SWCPP Ref. No.:	PPSSWC-329
DA No.:	DA23/0281
PROPOSED DEVELOPMENT:	Staged Construction Of A Mixed Use Re-Development (Caddens Corner) Involving The Construction Of 18 Buildings, 469 Residential Apartments, Five (5) Commercial Premises, Basement Car Parking & Associated Demolition, Tree Removal, Construction of Roads, Earthworks, Landscaping & Stormwater Drainage Works
PROPERTY ADDRESS:	68-80 O'Connell Street, Caddens, NSW, 2747 Lot 2 DP 1268507 & Lot 1 DP 1268507
PROPERTY DESCRIPTION:	Caddens Corner
ZONING:	E1 Local Centre, R4 High Density Residential
ASSESSING OFFICER:	Consultant Planner – Nicholas Cavallo (Knight Frank Town Planning)
APPLICANT:	Caddens Estate Pty Ltd C/- Think Planners
DATE RECEIVED:	27 April 2023
REPORT BY:	Knight Frank Town Planning on behalf of Penrith City Council's Development Services
RECOMMENDATIONS:	Refusal

Assessment Report

Figure 6: 3D Height Blanket Natural Ground Level (Source: Turner)

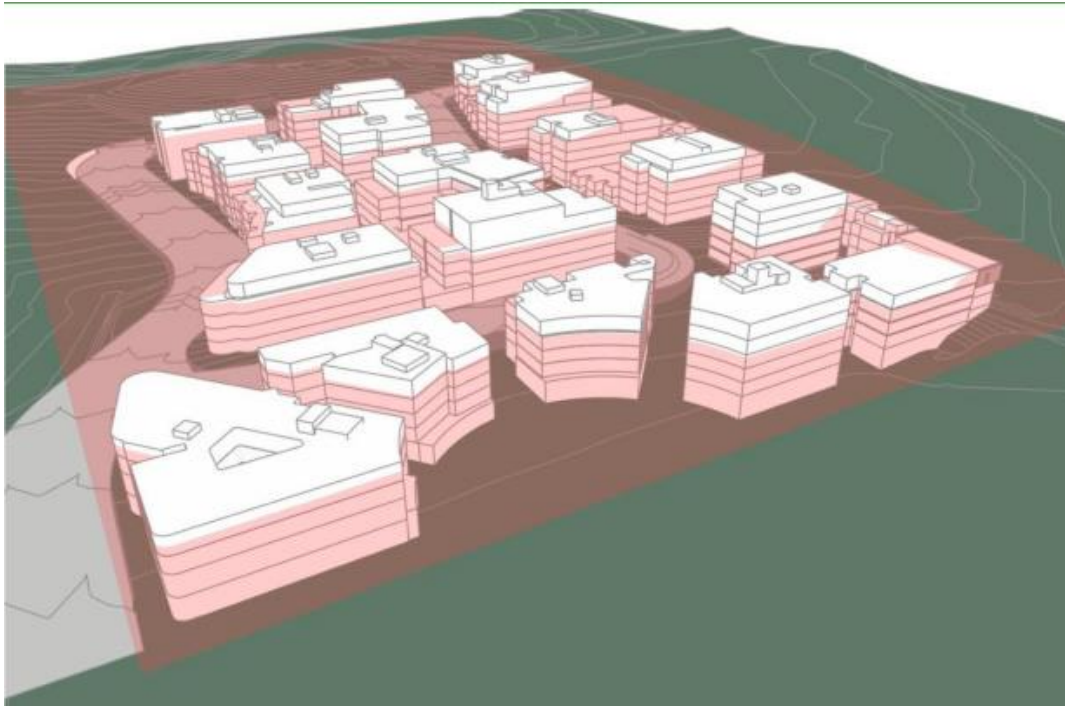
As outlined in the submitted urban design analysis and in the supporting clause 4.6 written statement the applicant has introduced a rationalised height plane that assumes what the natural ground levels were prior to the modification of the site for its historic use as a drive in theatre and current use as a shopping centre and at grade car park. The applicant acknowledges that the correct way to measure building height is not based on the rationalised height limit but provides this as context for the urban design response.

Using the 'rationalised height plane' approach the development results in 10 of the 18 buildings exceeding the permitted building height. An assessment against the provisions of clause 4.6 is undertaken below.

In essence this measurement projects the 15m height limit taken from O'Connell Street to the south rather than using the existing ground levels. The height then basically meets the existing ground levels within the northern part of the site. A review of historic aerial photos (see Figure 4) for the site suggests that the drive in theatre and Caddens Corner shopping centre was largely contained to the western part of the site (current Lot 1 DP1268507).
